NINE MILE POINT NUCLEAR STATION

SUBJECT: Nine Mile Point Nuclear Station
Unit No. 1, Docket No. 50-220

License Amendment Request Pursuant to 10 CFR 50.90 Modifying Surveillance Requirements for Testing of the Main Steam Electromatic Relief Valves (Technical Specification Sections 4.1.5 and 4.2.9) and Associated Inservice Testing 10 CFR 50.55a Request

**Figure 1
ERV Component Configuration**

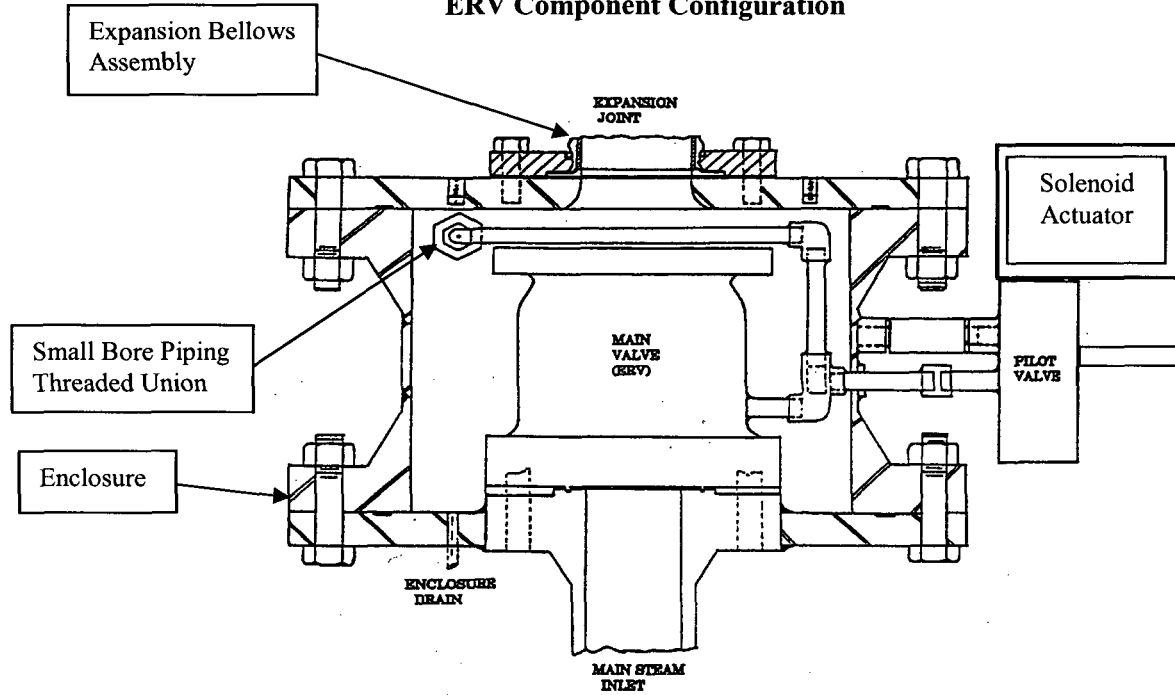
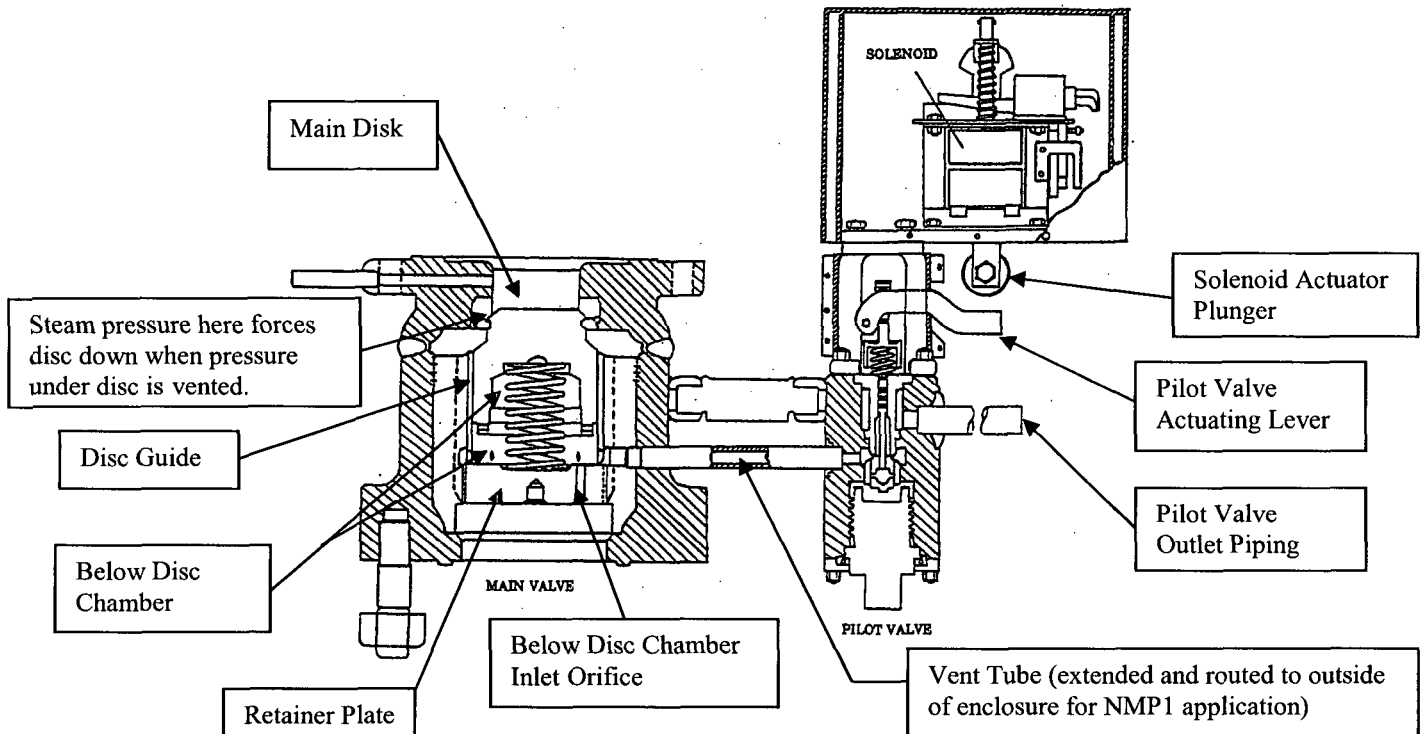
The ERVs are solenoid-actuated, pilot-operated relief valves. The valves operate in conjunction with actuation instrumentation for both the ADS and overpressurization relief modes and, thus, do not rely on spring setpoints for valve actuation. The three principal ERV components are the main valve, the pilot valve assembly, and the solenoid actuator. Refer to Figure 1 for component configuration.

A unique design feature of the NMP1 ERVs is that the main valve is housed in a heavy steel enclosure that is attached to the main steam line inlet flange (shown in Figure 1). The pilot valve assembly is installed inside the pilot valve housing, and the housing is mounted on the enclosure and physically separated from the ERV main valve body. Small bore piping is used to extend the main valve vent tube and route it through the enclosure for connection with the pilot valve. The ERV main valve outlet is open-ended such that the steam is discharged inside the steel enclosure and out to the discharge piping through a bellows assembly. The steel enclosures were installed in 1972 for the purpose of providing a pressure boundary for the main valve discharge, while also relieving the mechanical loads from the ERV housing by transferring them to the main steam piping system. These loads were suspected of causing main valve body deflections, which resulted in main steam leakage past the main valve disc seat.

Main valve testing will be performed at an offsite steam test facility. As described in Section 2.2.2 above, the main valve is housed in a heavy steel enclosure that is attached to the main steam line inlet flange. The pilot valve assembly is installed inside the pilot valve housing, and the housing is welded onto the outside of the enclosure and physically separated from the ERV main valve body. Thus, only the main valve of the ERV can be sent to the test facility. A spare pilot valve assembly and a spare solenoid actuator, both representative of the components used at the plant, will be installed at the test facility to allow testing the main valve. The valve will be installed on a test steam header in the same orientation as the plant installation. The test conditions at the test facility will be similar to those in the plant, including ambient temperature and steam conditions. The main valve will receive an initial seat leak test, a functional test to ensure it is capable of opening and closing, and a final seat leak test. Valve stroke time will be obtained during the exercise test. Valve seat tightness will be verified by a cold bar test, and if not free of fog, leakage will be measured and verified to be below specified acceptance criteria.

**Figure 1
ERV Component Configuration**

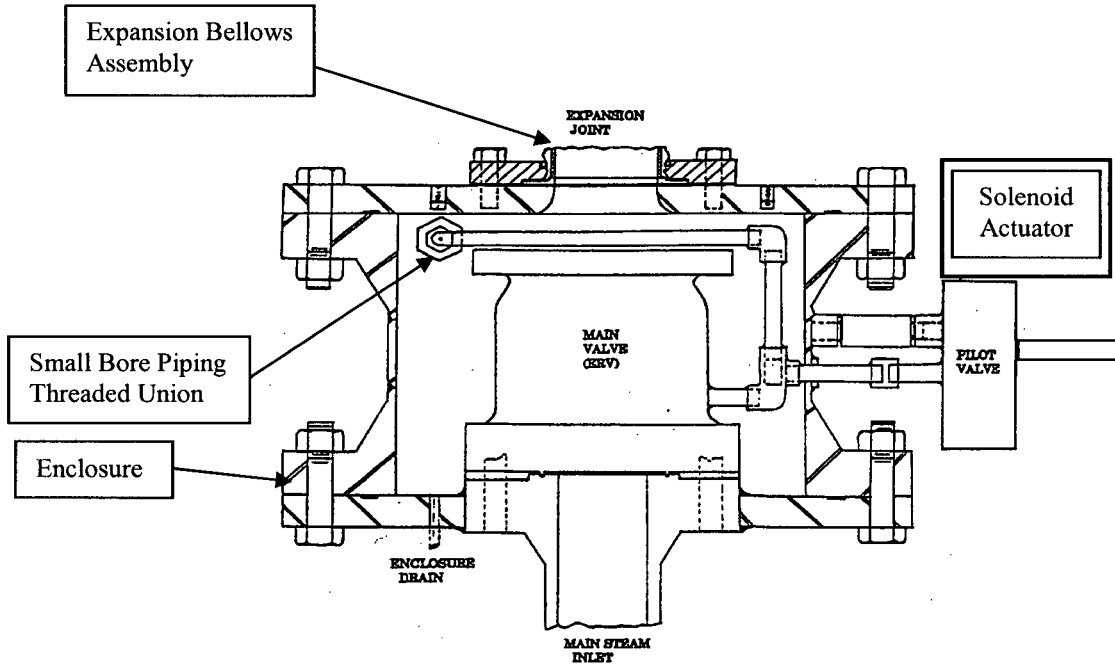
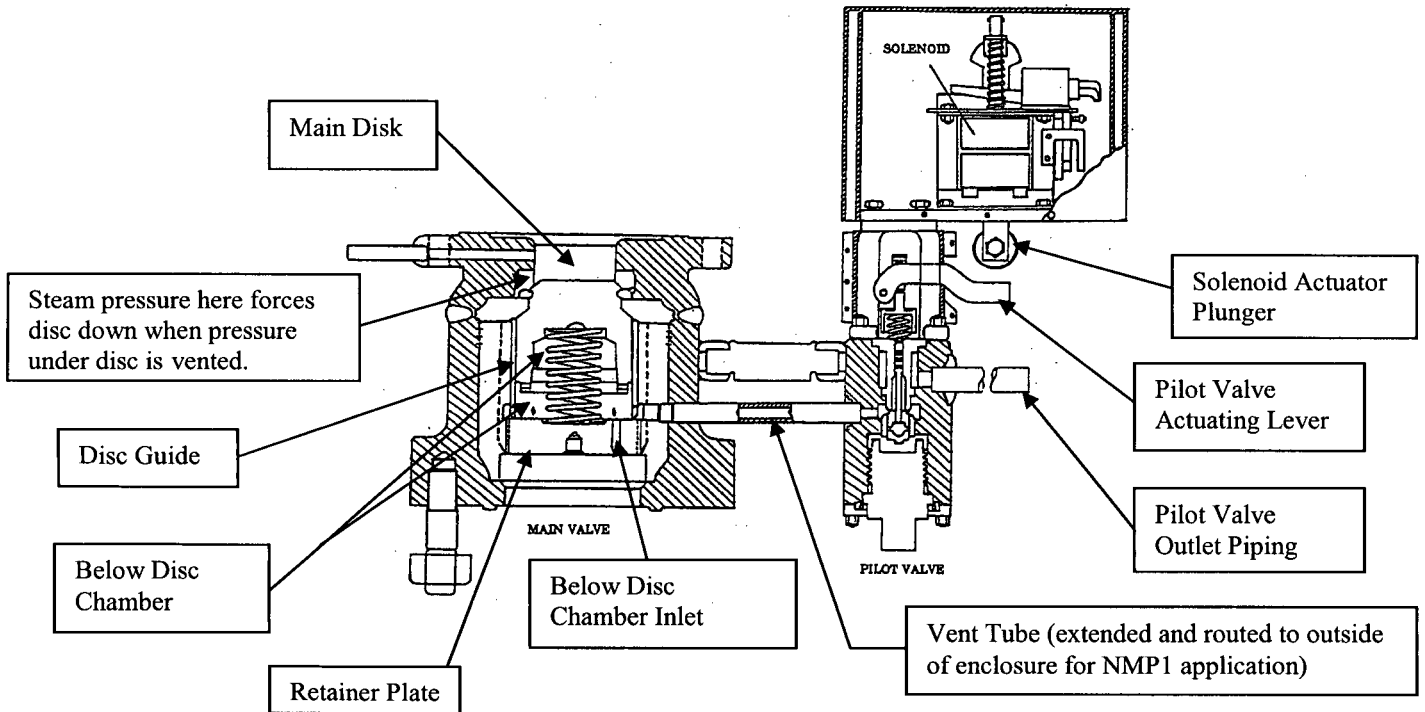
There are six ERVs installed on the main steam lines inside the drywell. Each ERV consist of a main valve, a pilot valve assembly, and a solenoid actuator (see Figure 1). The ERVs are opened by either signals from automatic actuation instrumentation or manually and, thus, do not rely on spring setpoints for valve actuation.

Main valve testing will be performed at an offsite steam test facility. As shown in Figure 1, the main valve is housed in a heavy steel enclosure that is attached to the main steam line inlet flange. The pilot valve assembly is installed inside the pilot valve housing, and the housing is welded onto the outside of the enclosure and physically separated from the ERV main valve body. Thus, only the main valve of the ERV can be sent to the test facility. A spare pilot valve assembly and a spare solenoid actuator, both representative of the components used at the plant, will be installed at the test facility to allow testing the main valve. The valve will be installed on a test steam header in the same orientation as the plant installation. The test conditions at the test facility will be similar to those in the plant, including ambient temperature and steam conditions. The main valve will receive an initial seat leak test, a functional test to ensure it is capable of opening and closing, and a final seat leak test. Valve stroke time will be obtained during the exercise test. Valve seat tightness will be verified by a cold bar test, and if not free of fog, leakage will be measured and verified to be below specified acceptance criteria. This initial testing will be completed prior to plant startup from the refueling outage.
